STATE OF WISCONSIN
DEPARTMENT OF TRANSPORTATION
PLAN OF PROPOSED IMPROVEMENT
FOND DU LAC - PLYMOUTH
CTH K - ECL
STH 23
FOND DU LAC COUNTY

TRANS 220
PROJECT PLAN
FOR
DESIGN OF UTILITY FACILITY
ALTERATIONS OR RELOCATIONS

UTILITY WORKSHEET

Utility Company Name AT&T Wisconsin - Communication Line	PLEASE RETURN THIS WORKSHEET BY July 29, 2019 DENIED 8/13/2019 JJO
Project Description Design Project ID: 1440-15-01 Construction Project ID: 1440-15-72 and 1440-15-73 FOND DU LAC - PLYMOUTH SEVEN HILLS ROAD-EAST COUNTY LINE STH 23, Fond Du Lac County	RETURN TO Jeff Orr Division of Transportation System Development Northeast Region 944 Vanderperren Way Green Bay WI 54304

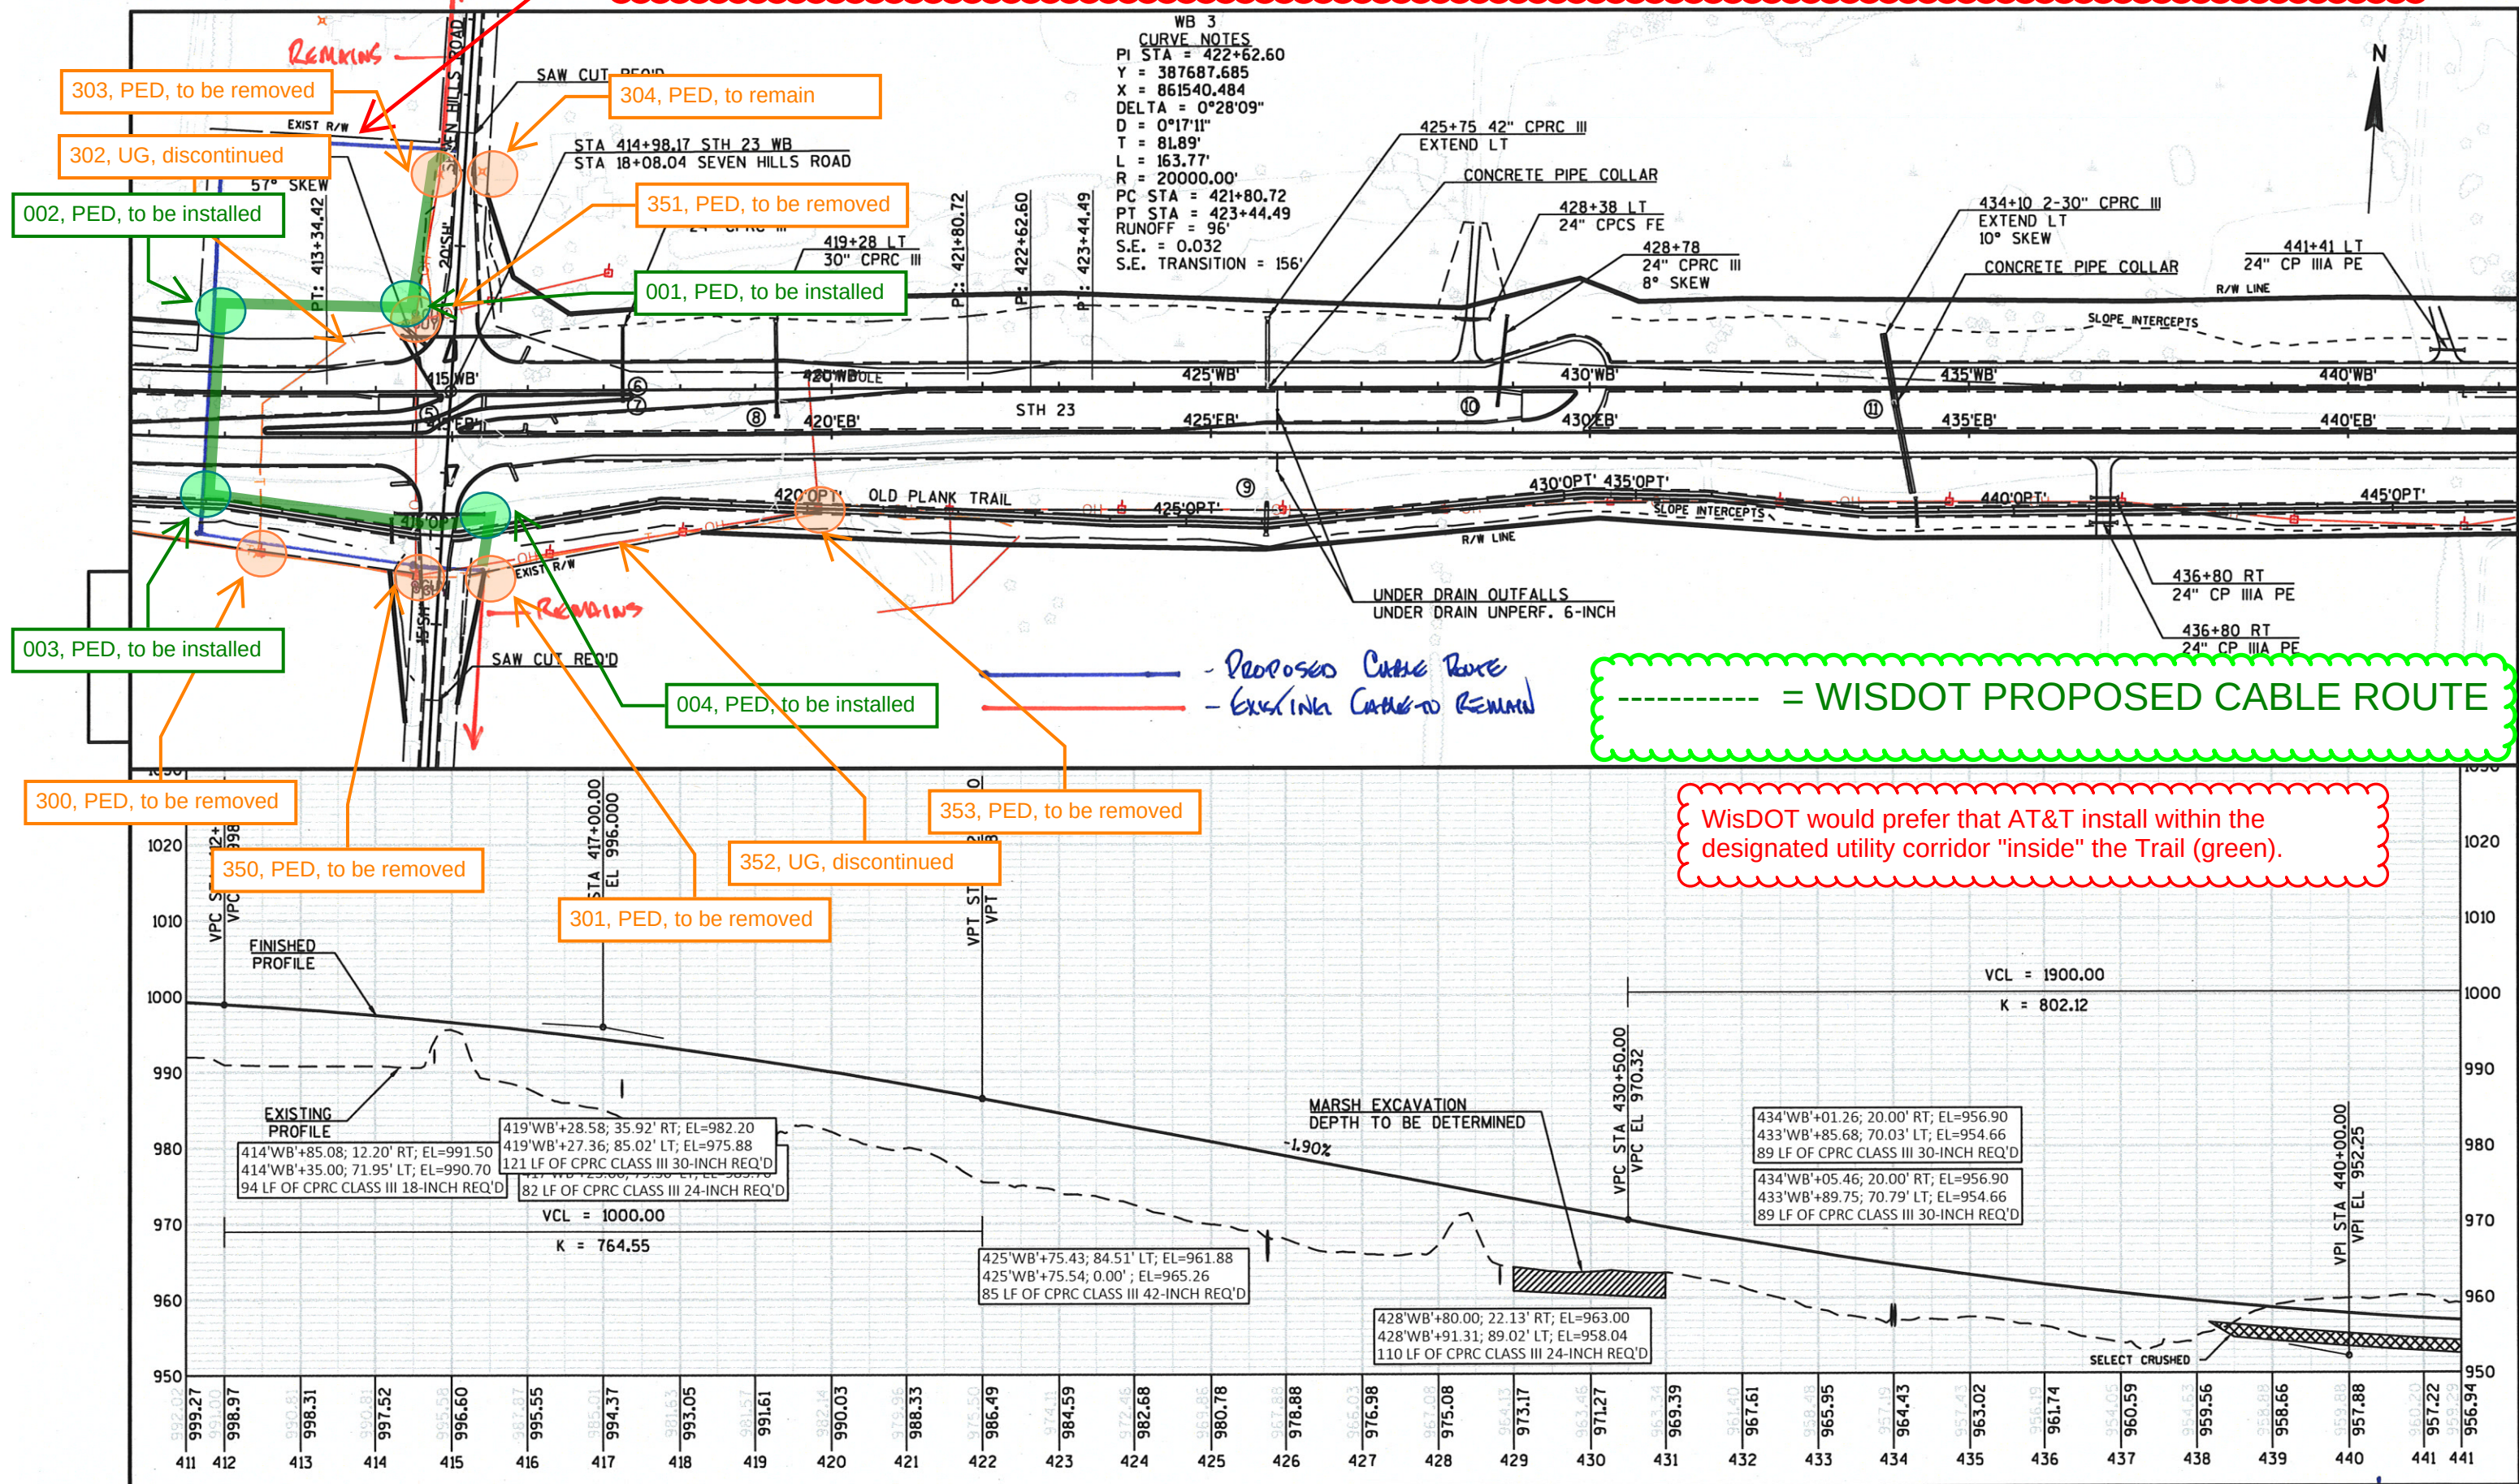
WisDOT would prefer to have the underground facility located along the proposed slope limit (green) and not the along the proposed right of way (blue)

----- = WISDOT PROPOSED CABLE ROUTE

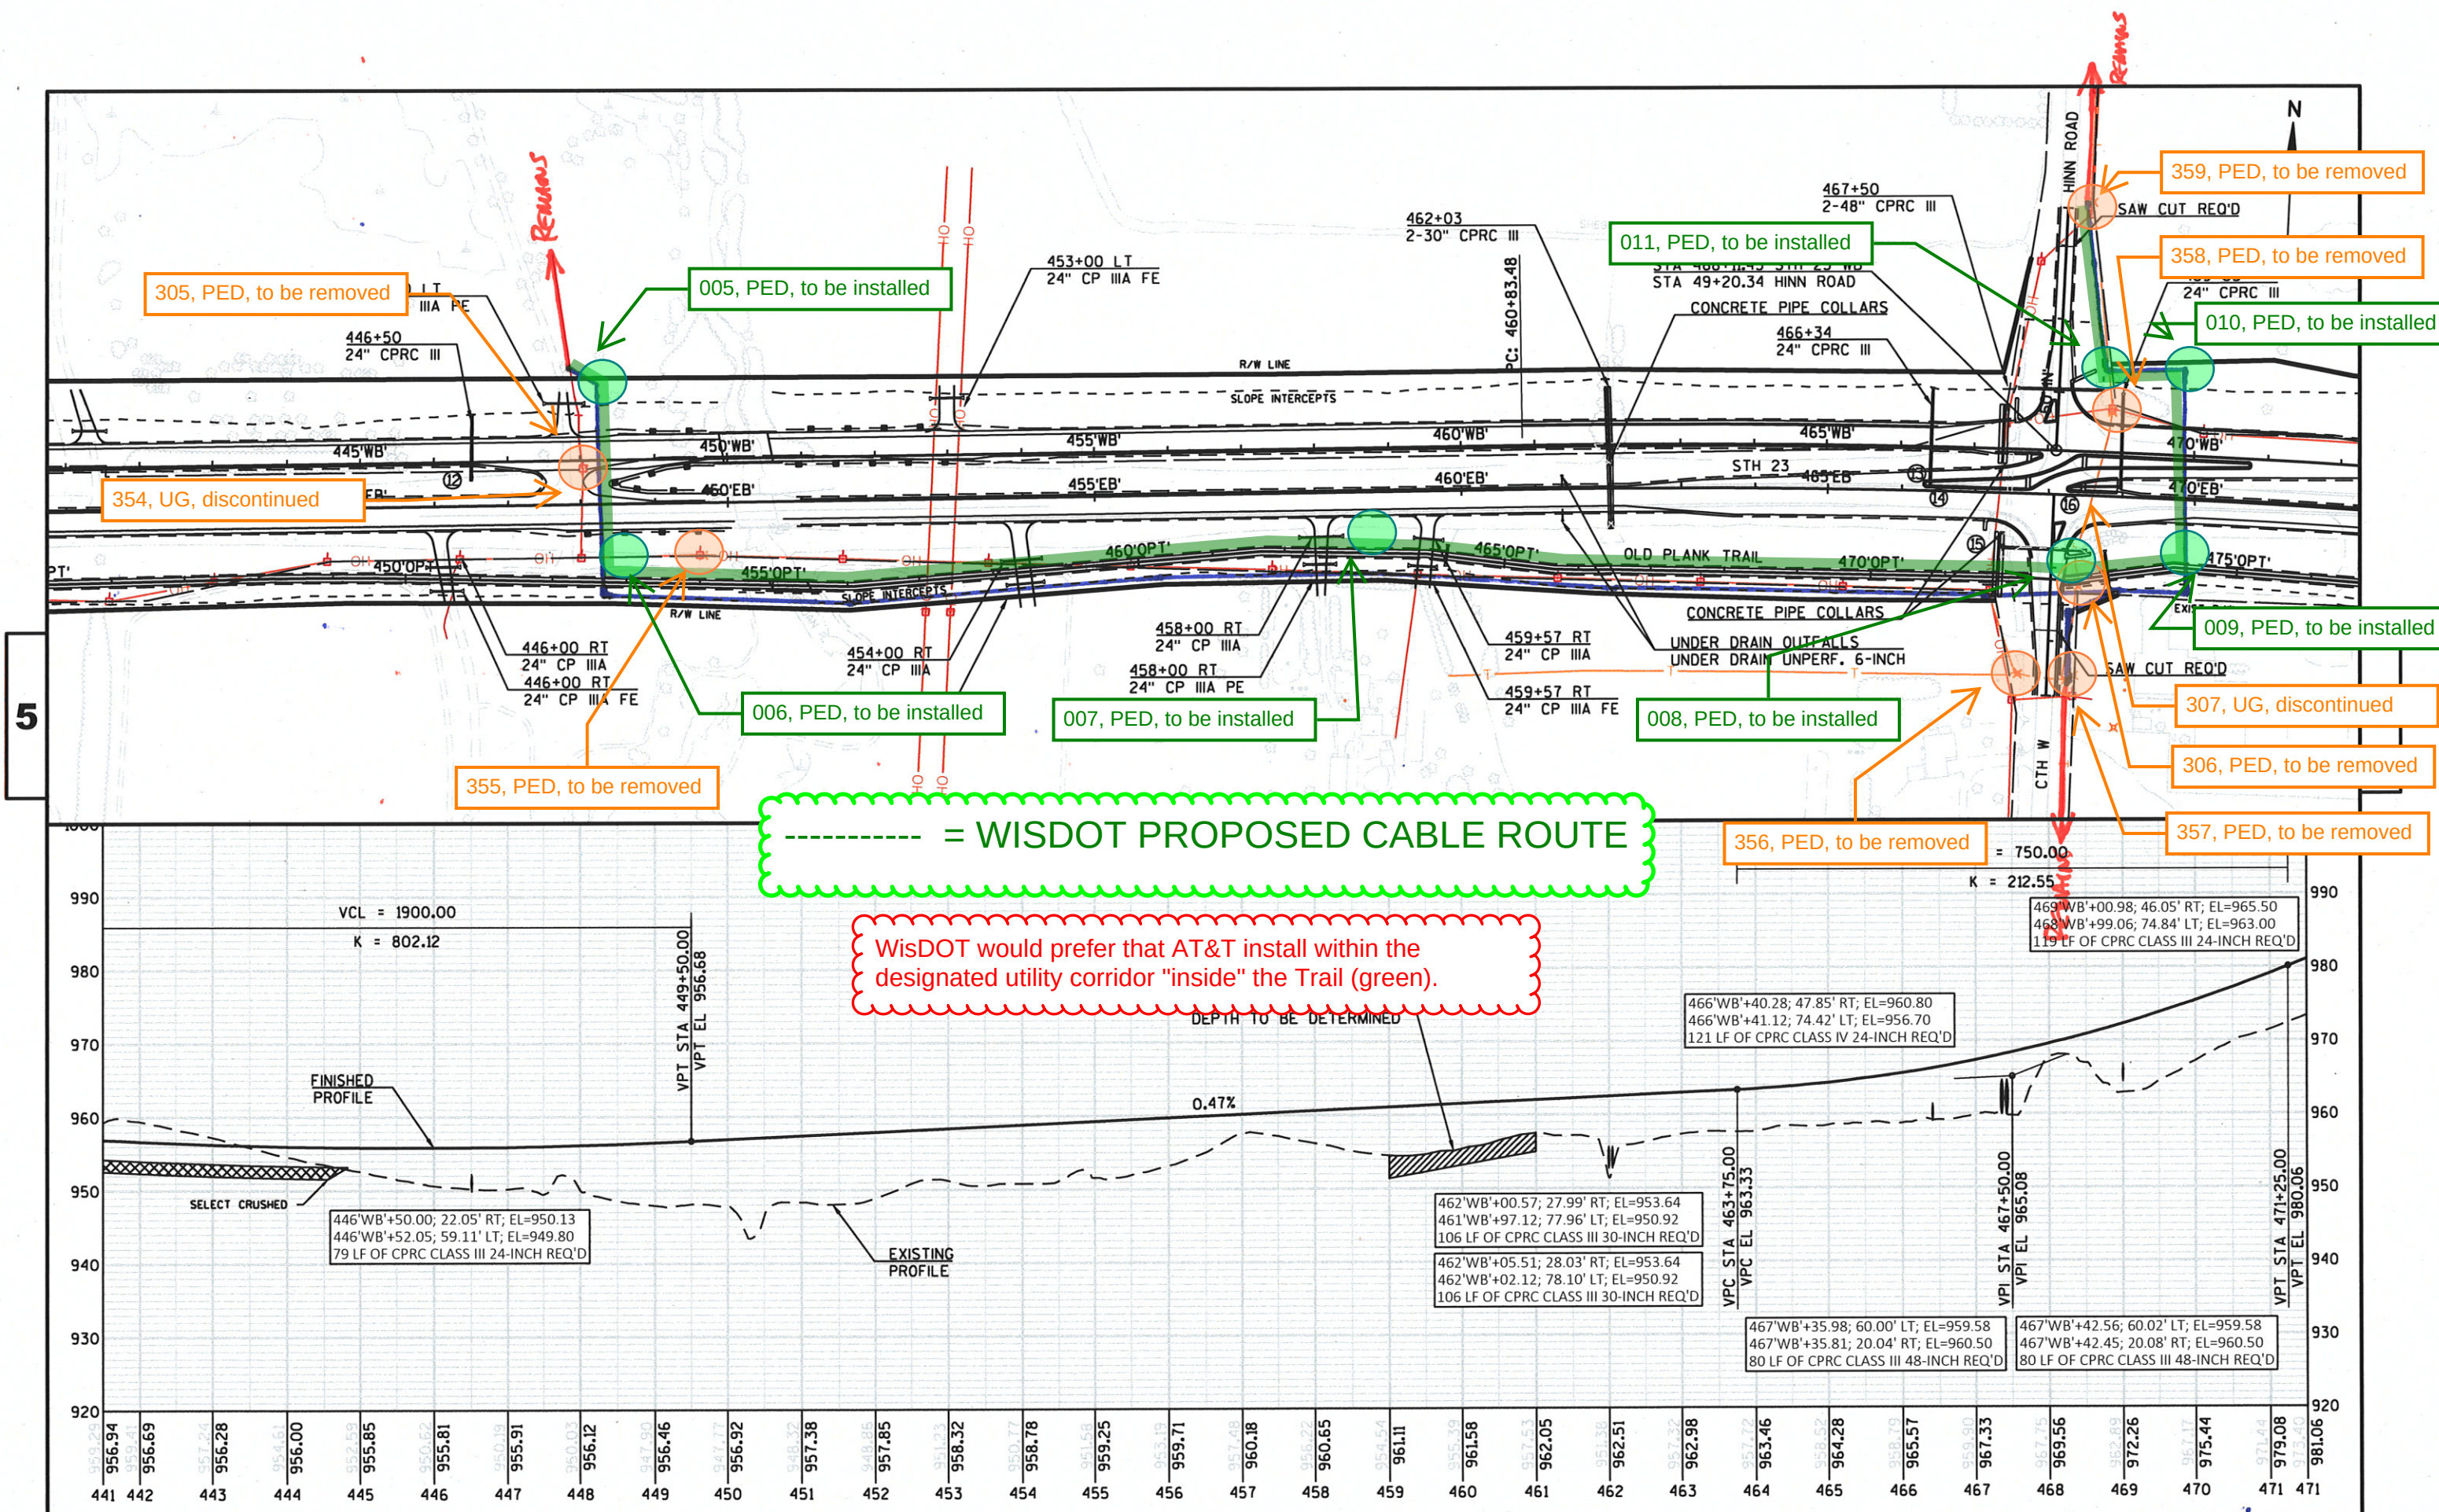
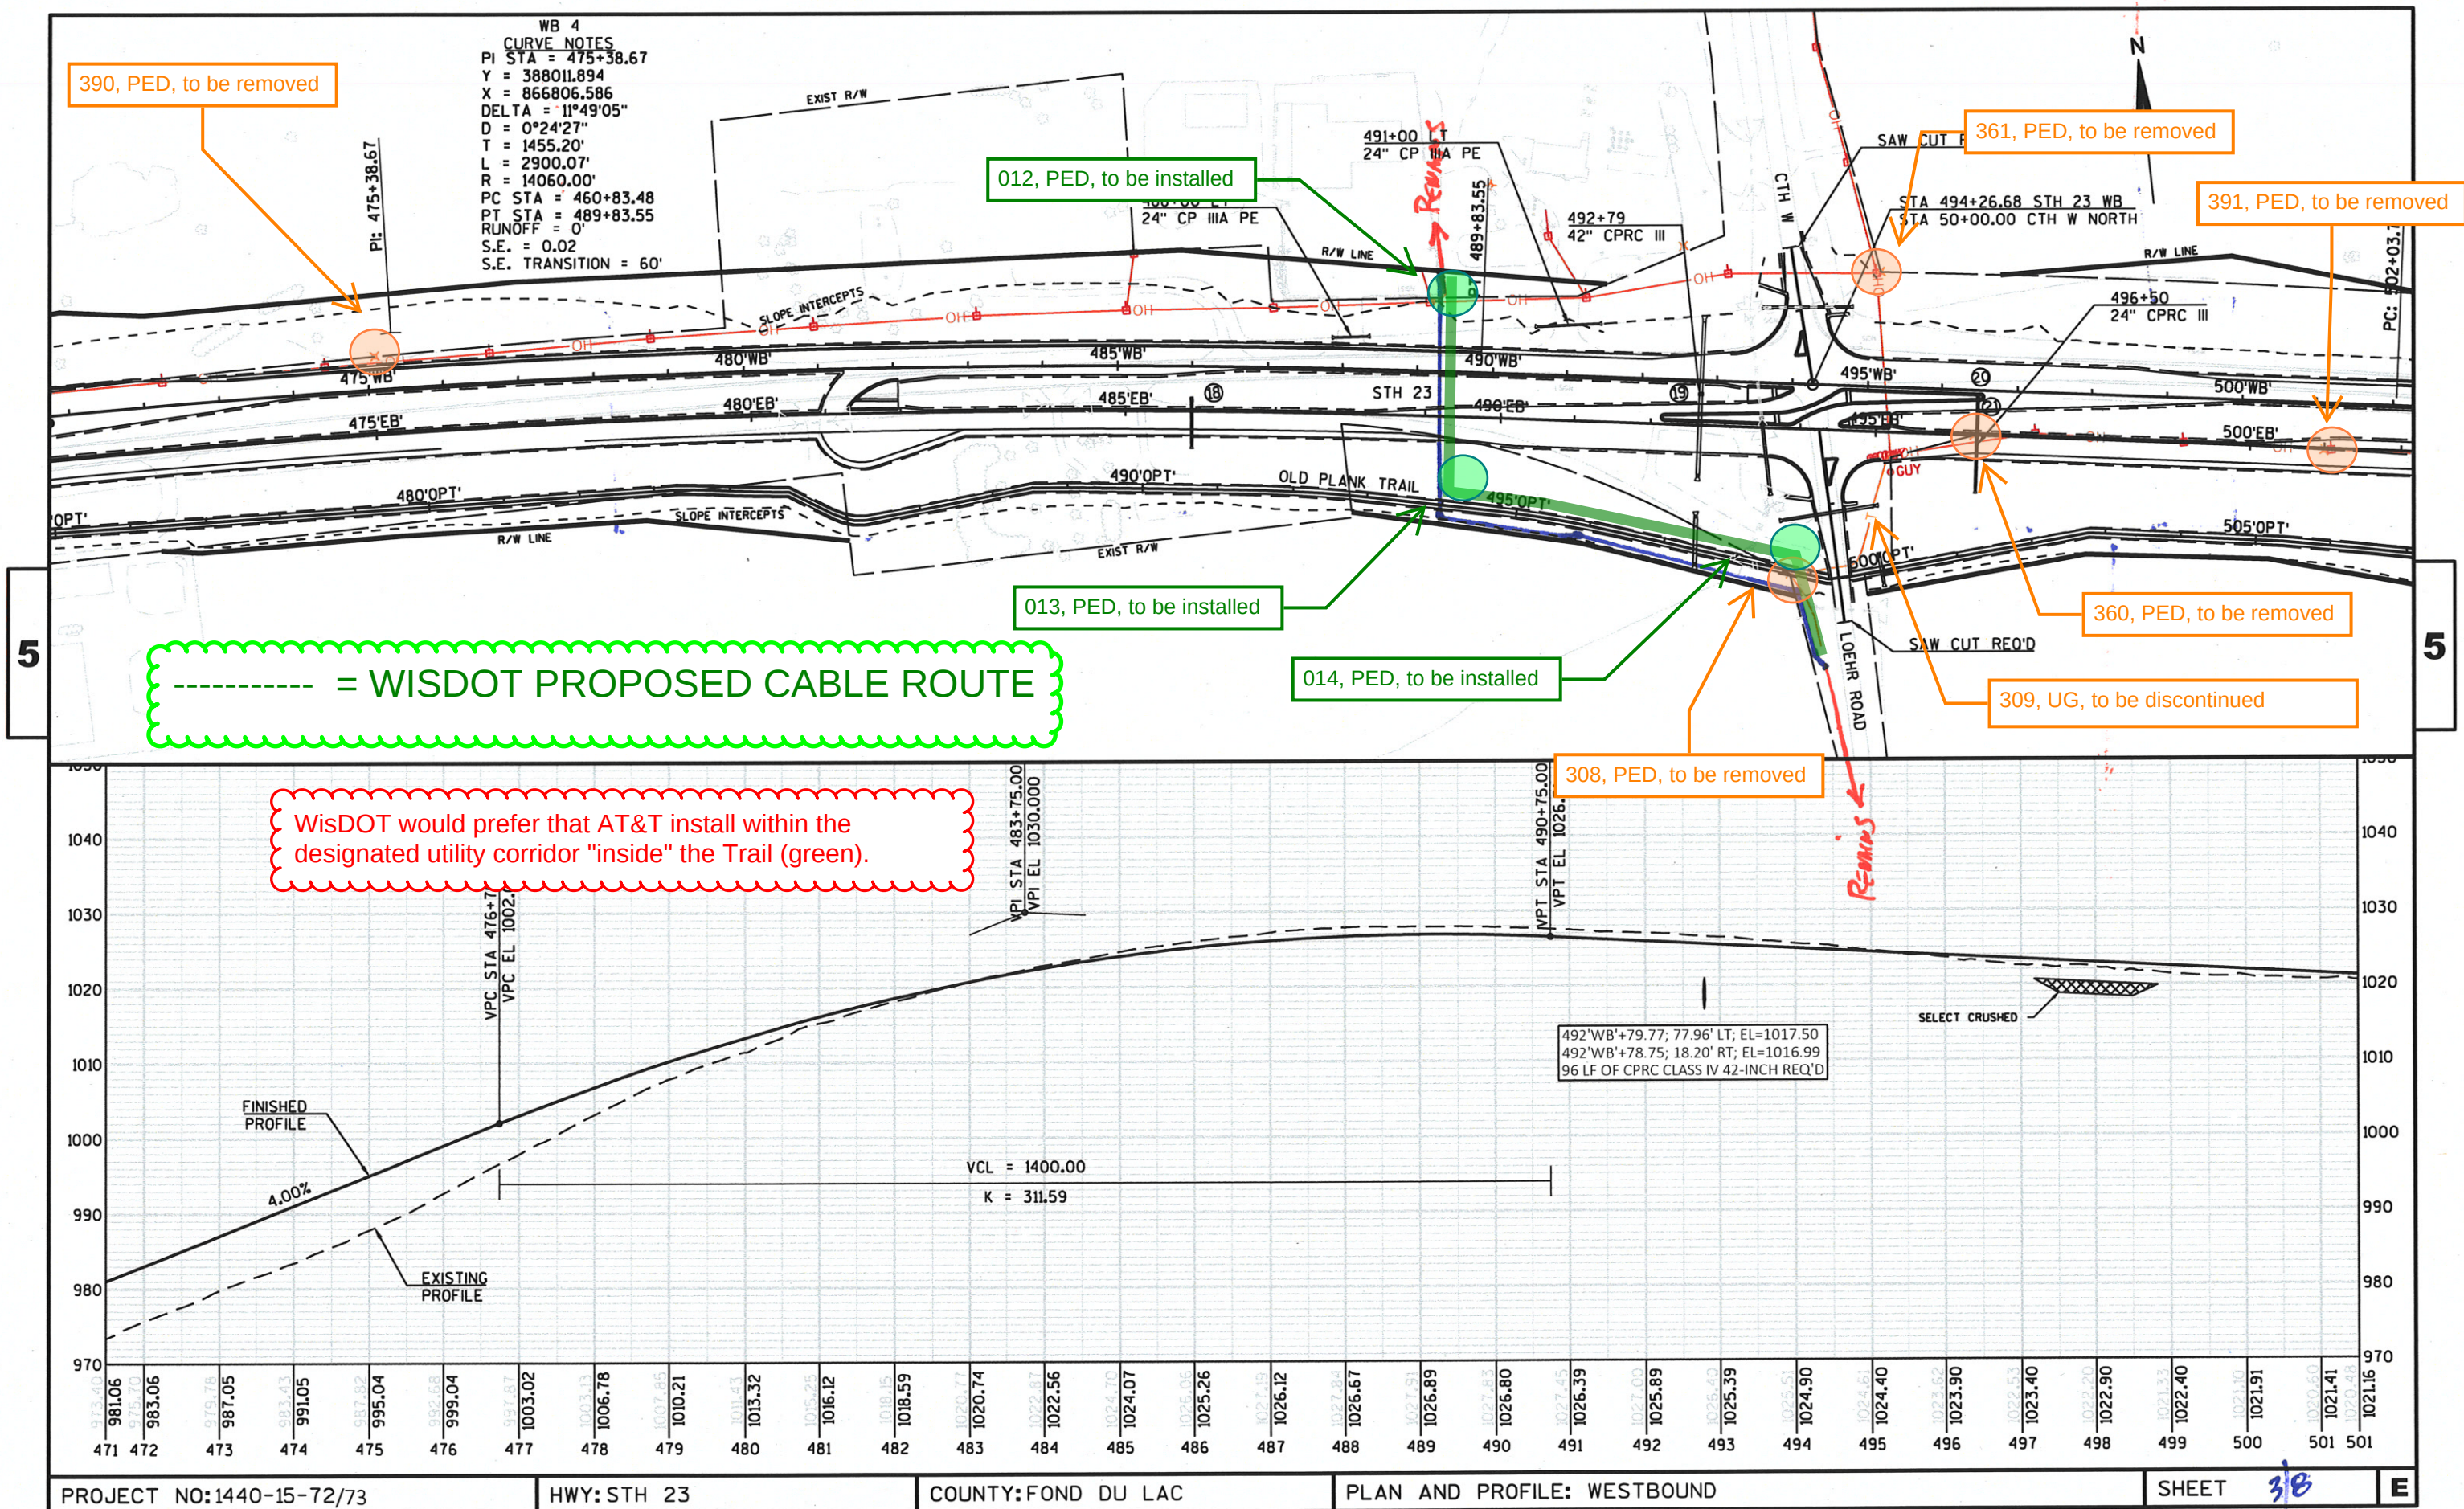
WisDOT would prefer that AT&T install within the designated utility corridor "inside" the Trail (green).
